Clash Publish

Clash Computation Specification			
Products Selected		Value	Status
AT732516MQ - FT PIPES (RUN)	ZHX_0001 - ACCESS ELEVATORS - GLOBAL ENVELOPE	-106.5	Not Relevant
	AT112396MQ - BT HEATER CABLE DISTRIBUTION - FOR FOOT R *	-1	Not inspected

Revised with Denis 27/07/2005

Clash

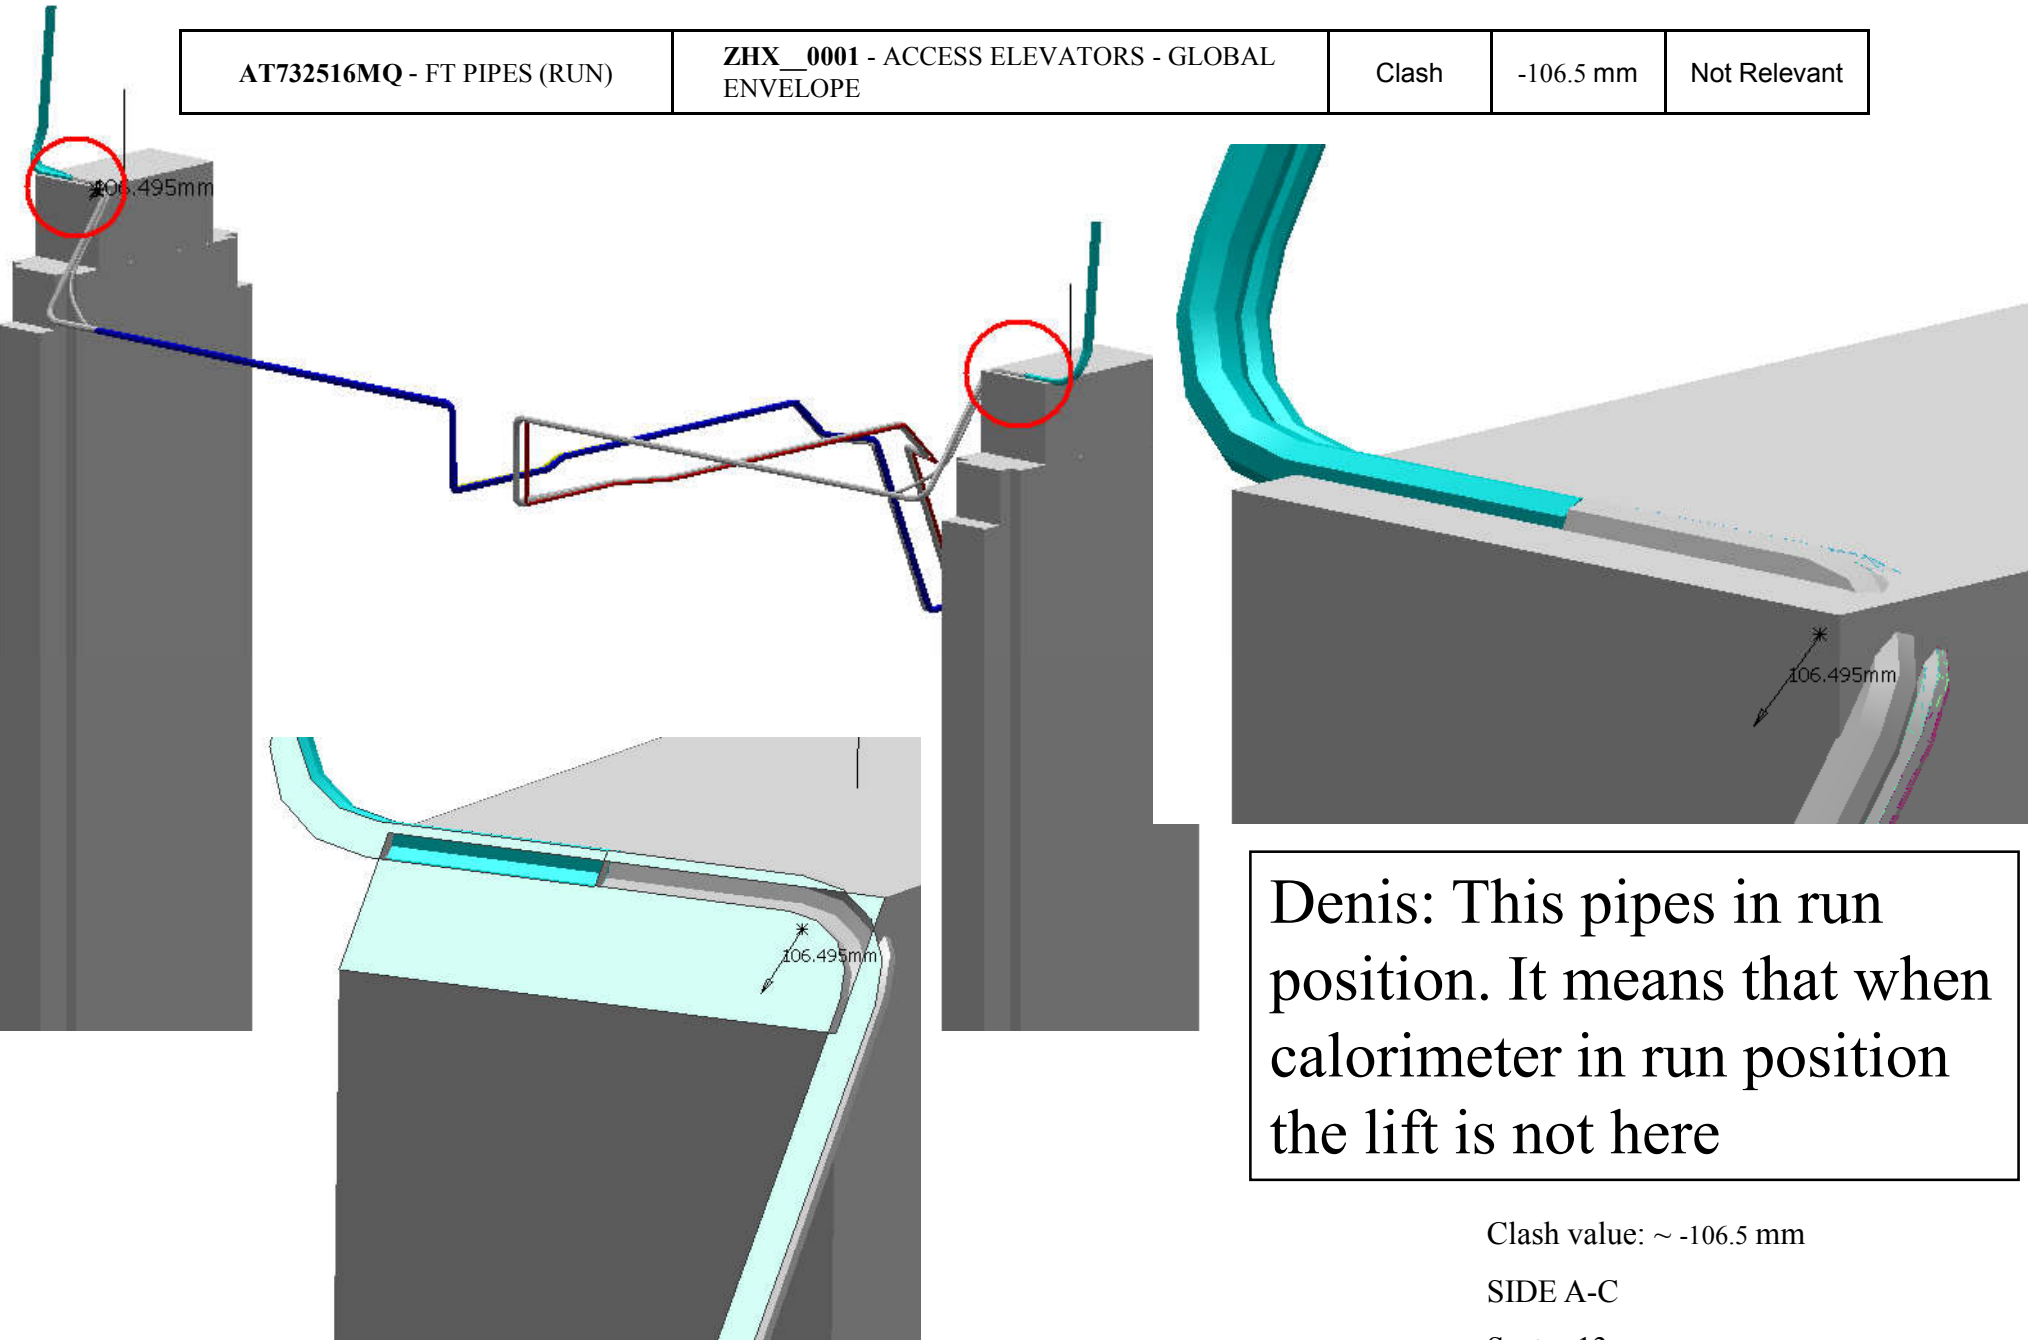
AT732516MQ - FT PIPES (RUN)

ZHX_0001 - ACCESS ELEVATORS - GLOBAL ENVELOPE

-106.5 mm

Clash value: ~ -106.5 mm

Not Relevant

Denis: This pipes in run position. It means that when calorimeter in run position the lift is not here
